<b>Docket Number:</b>	23-DECARB-03
<b>Project Title:</b>	2025 California Building Energy Action Plan
<b>TN #:</b>	268541
<b>Document Title:</b>	Home Energy Analytics, Inc. Comments - Avoid panel and grid upgrades by promoting simple use of NEC 220-87
<b>Description:</b>	N/A
<b>Filer:</b>	System
<b>Organization:</b>	Home Energy Analytics, Inc.
<b>Submitter Role:</b>	Public
<b>Submission Date:</b>	2/9/2026 11:04:24 AM
<b>Docketed Date:</b>	2/9/2026

**Avoid panel and grid upgrades by promoting simple use of NEC  
220-87**

## Comments from Home Energy Analytics on the **Draft 2025 Building Energy Action Plan**

Figure 1: Two sections of SDG&E bill showing Peak Demand for past year and month

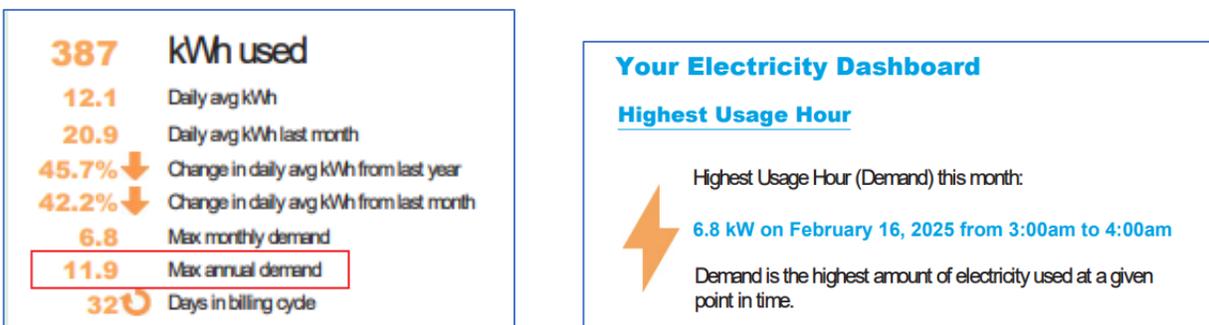
This somewhat complicated step could be completely avoided if all electric utilities in CA were required to communicate "peak demand" on their bills, via their customer portals, or both.

**At least two CA utilities do this already** for all customers: SDG&E and PAU (Palo Alto Utilities); see example screenshots below.
